UNITED STATES PATENT AND TRADEMARK OFFICE

10/781,320

Office Action Summary

FIG. 12

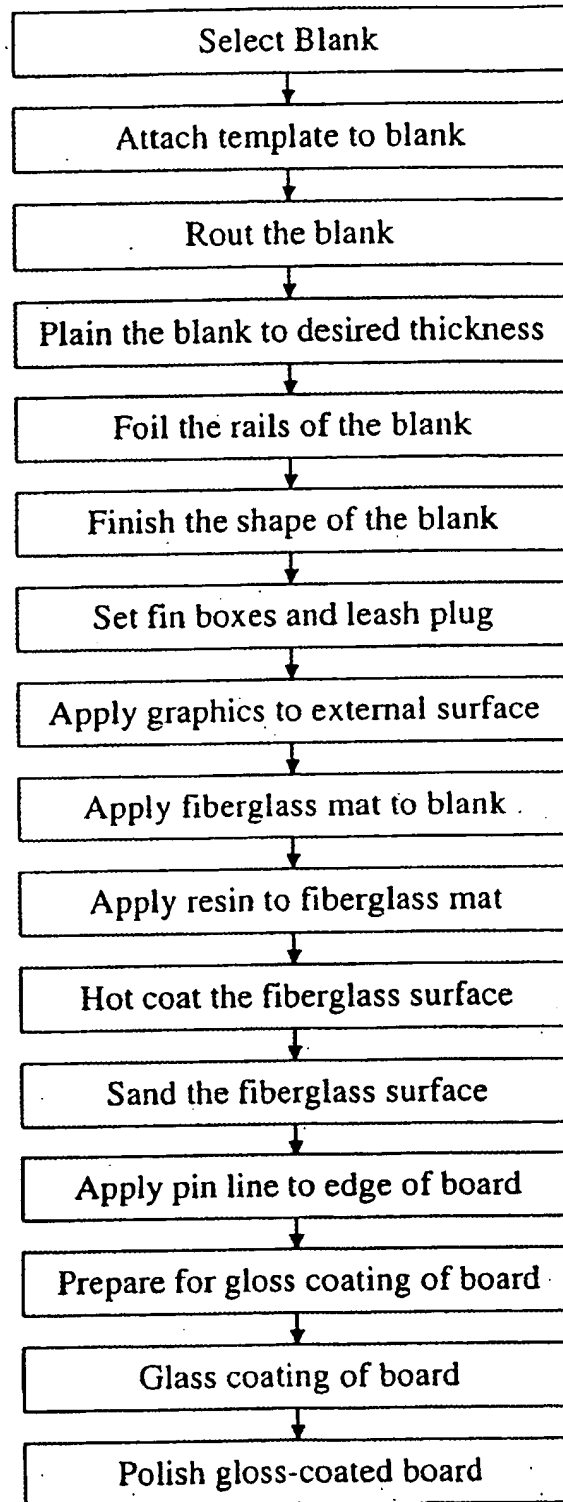
1. The replacement sheet of drawings filed June 20, 2005 has been approved.

*approved
for
7/11/05*
